Town Council Meeting

October 10, 2022 at 6:00 PM Howey-in the-Hills Town Hall 101 N. Palm Ave., Howey-in-the-Hills, FL 34737

Consideration and Approval: (First Reading) Ordinance 2022-019 - Reserve/Hillside GrovesDevelopment - PUD Amendment

- 4. Consideration and Approval: Appointment of Alan Hayes to the Planning and Zoning Board
- 5. Consideration and Approval: **Howey Self Storage Final Site Plan Submission**
- 6. Discussion: Retired Landfill Historic Overview
- 7. Consideration and Approval: Fencing around Town Lift Stations in Central Park and Griffin Park

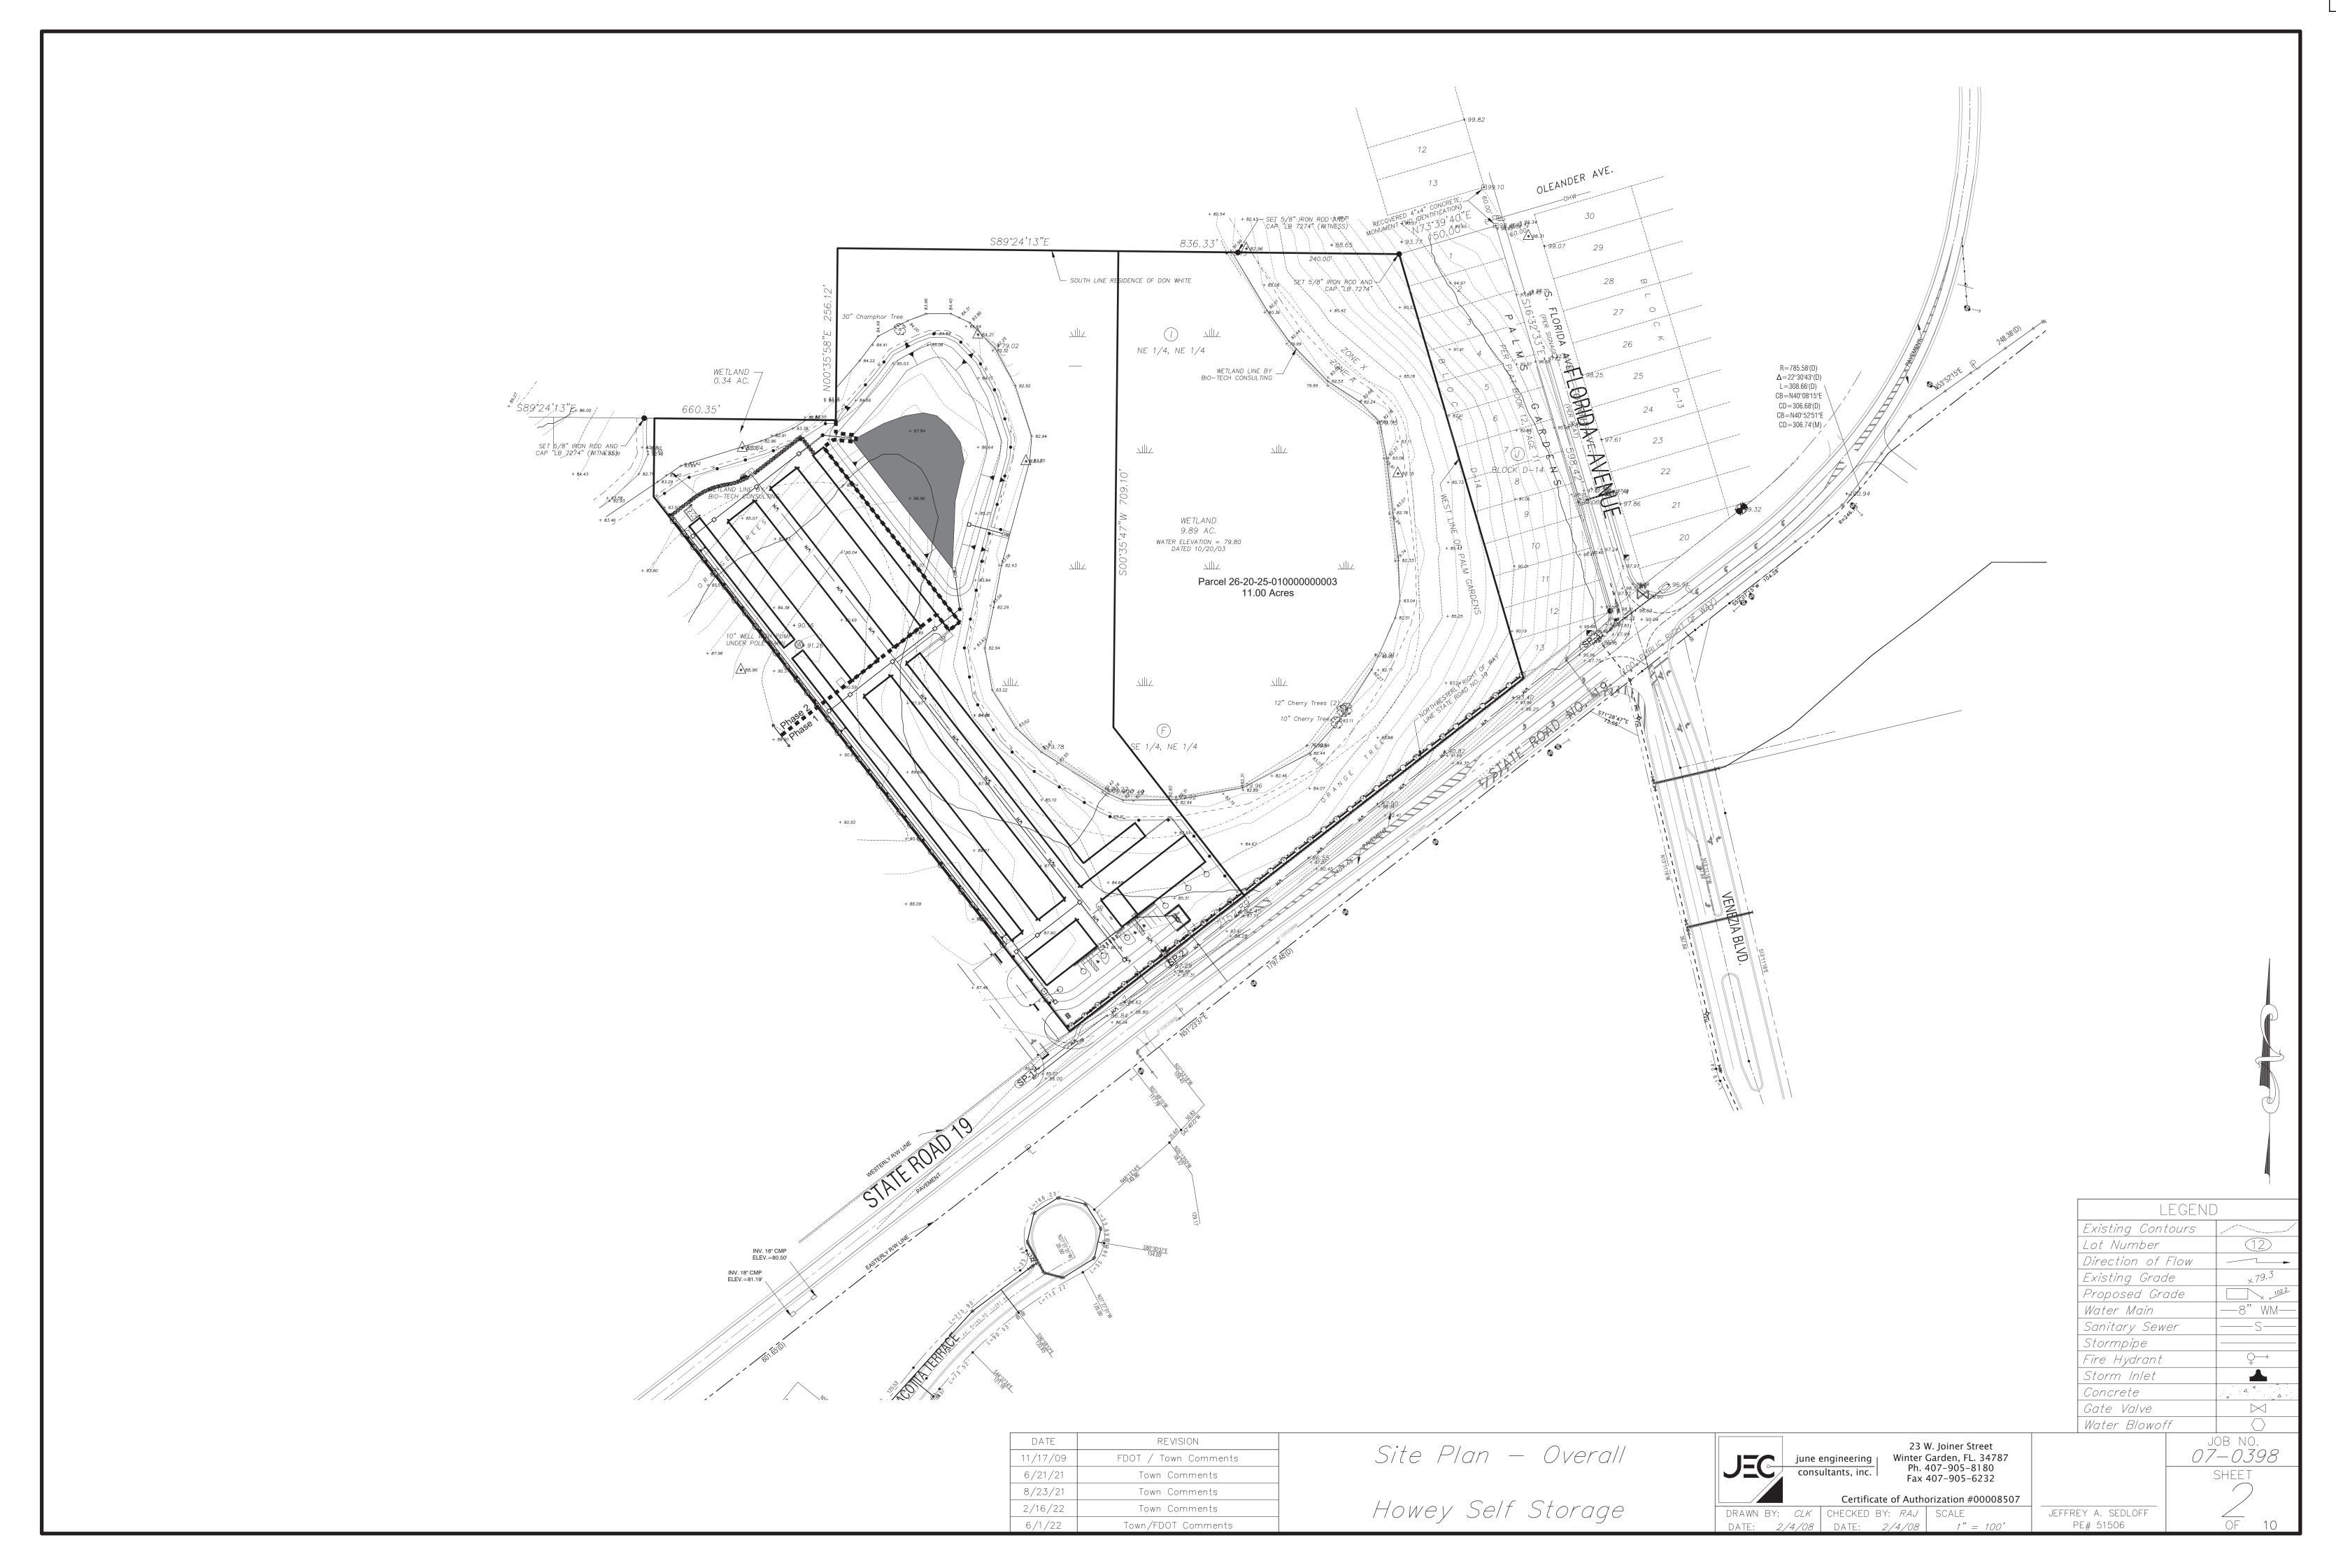
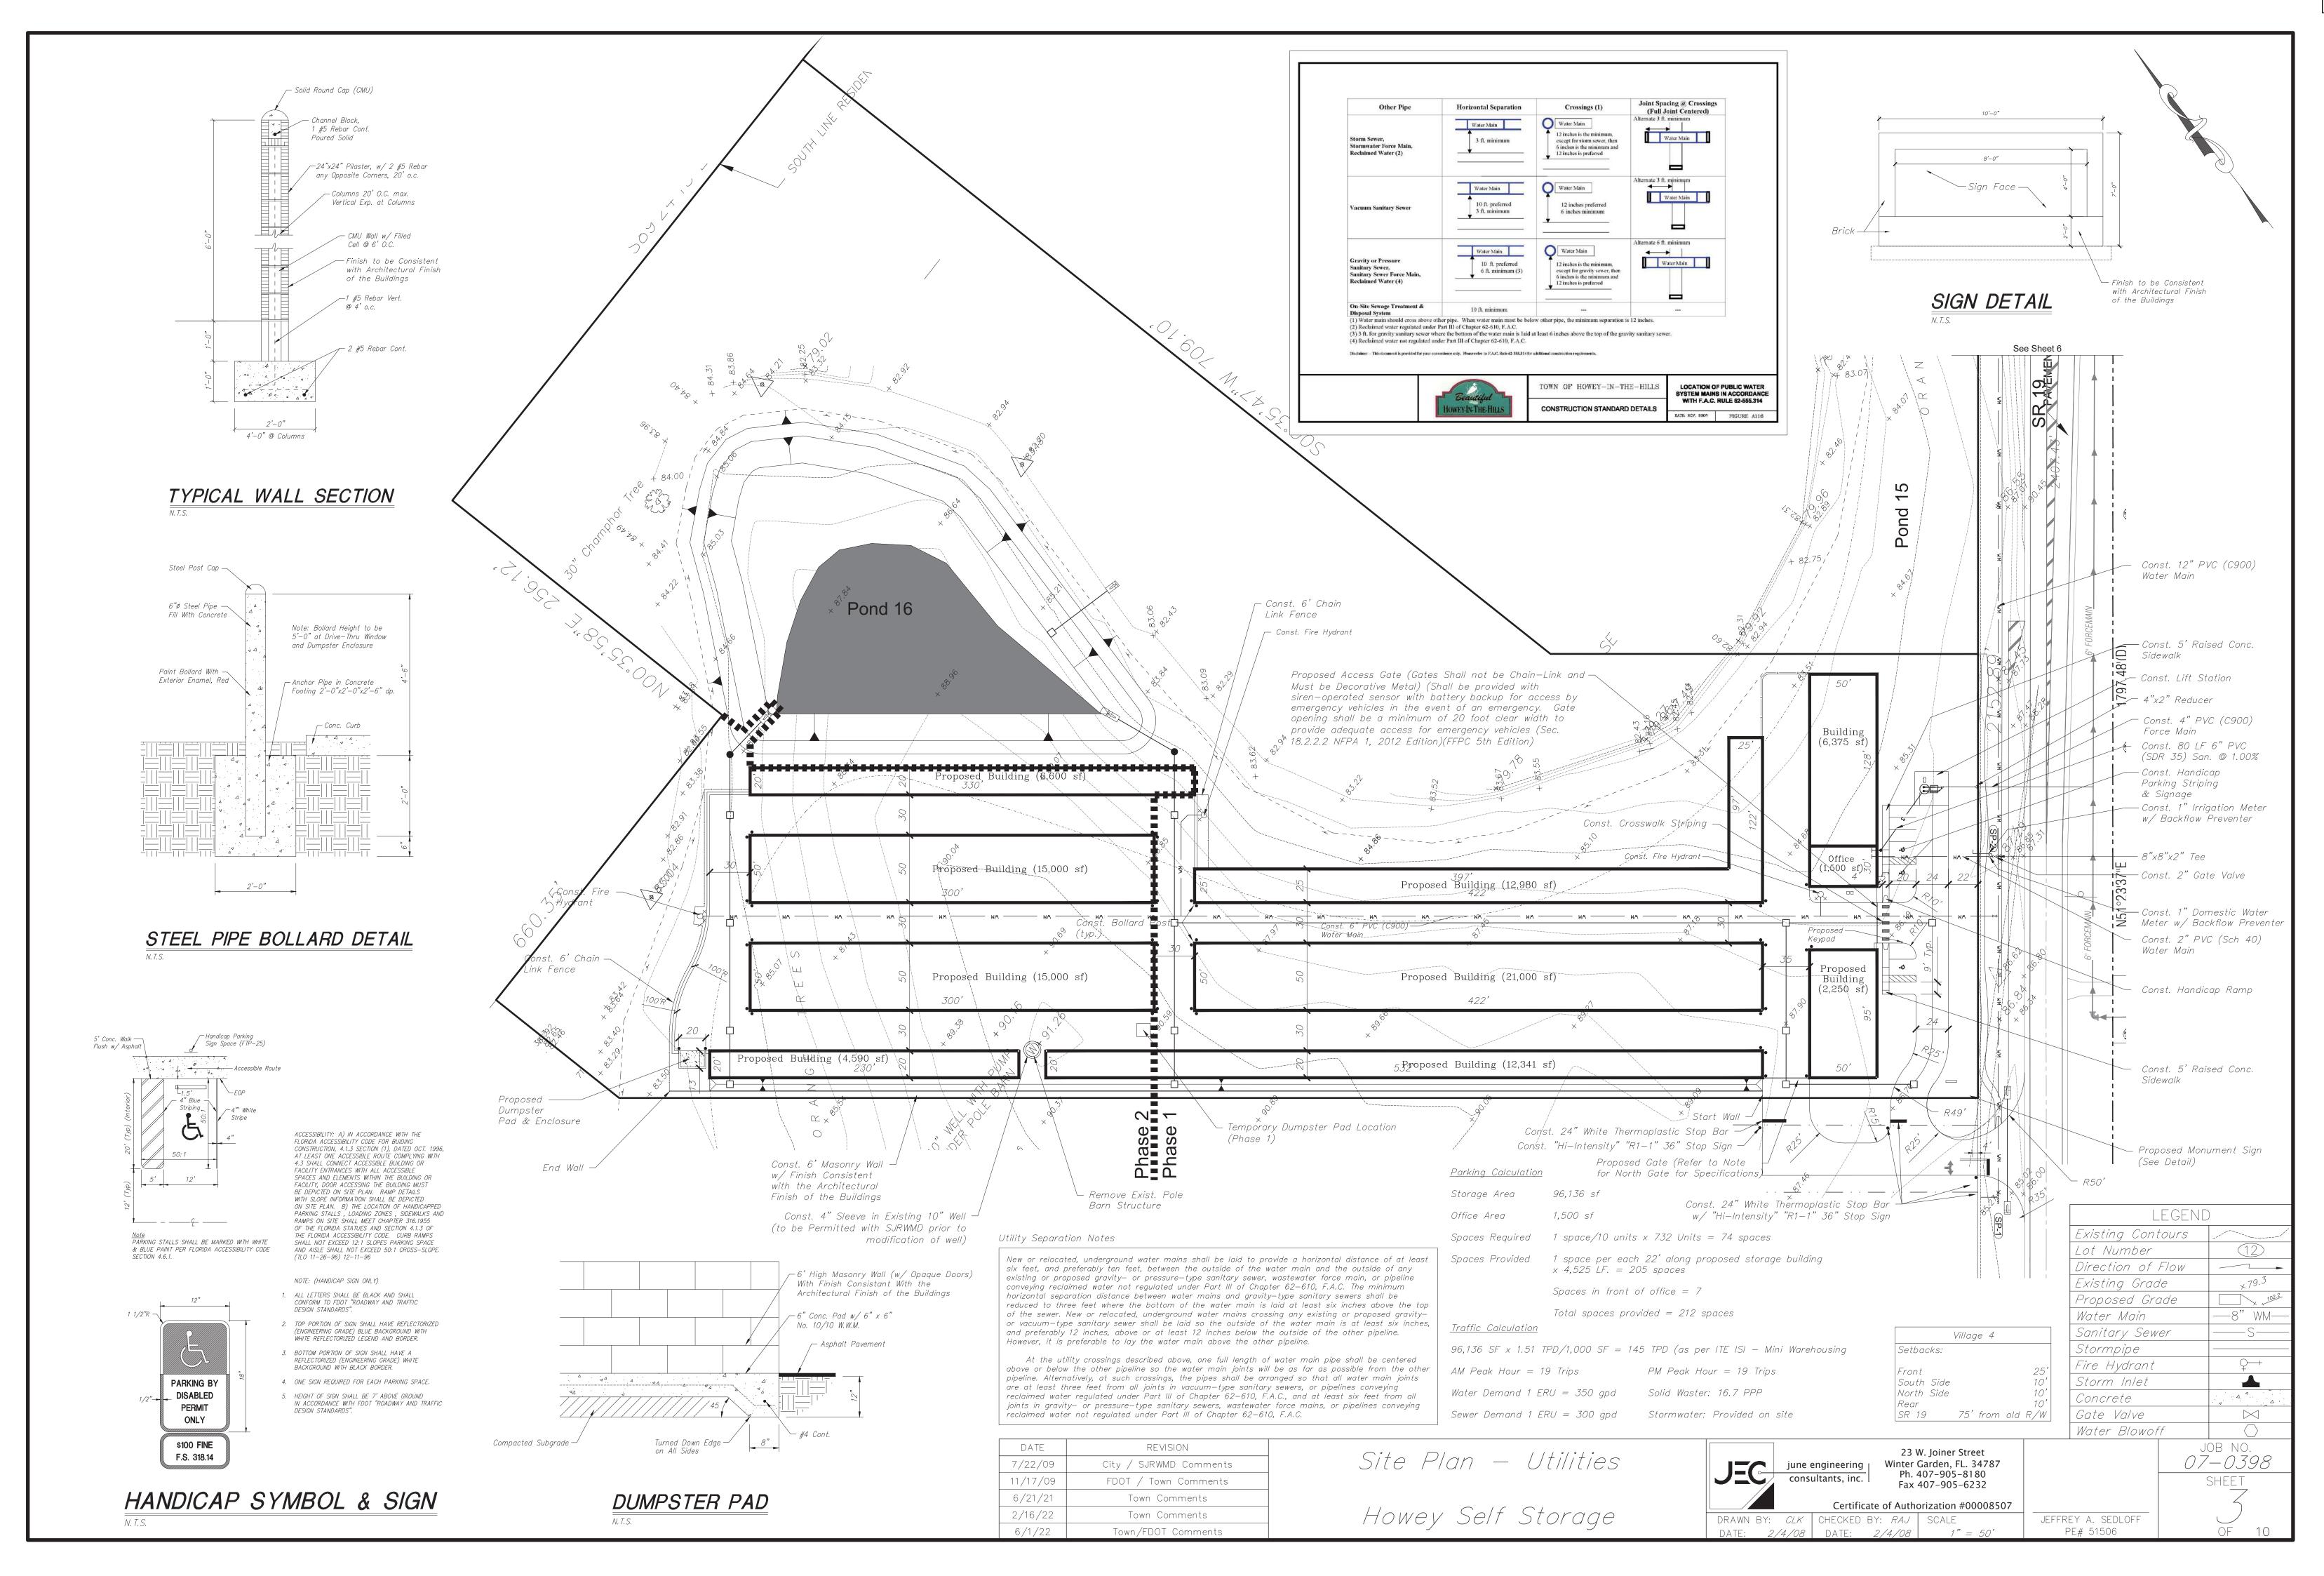
RESPONSE: The survey has been added as a separate page on sheet 5b.

RESPONSE: Parking calculations and additional building dimensions have been added to sheet 3. Stop bars & signs have been added and called out on sheets 4 and 6.

RESPONSE: The sidewalk has been added to section E on sheet 4.

RESPONSE: We have added sheet 5a to show the truck turning radii.

RESPONSE: Proposed crosswalk striping has been called out on sheet 3.

RESPONSE: The existing 4" water main has been shown on sheet 6 of the revised plans. We have shown this main to remain.

9. Update the Utility Connection Detail on sheet 6 to add the ex. 4" WM, correct the new WM size, remove the FM connection note.

10. Identify on the plan the water main jumper locations and BacT testing points. Add the town's temporary jumper detail PW-5A.

RESPONSE: Sample points SP-1, SP-2 and SP-3 are shown on sheet 6. The temporary jumper detail is shown on sheet 9.
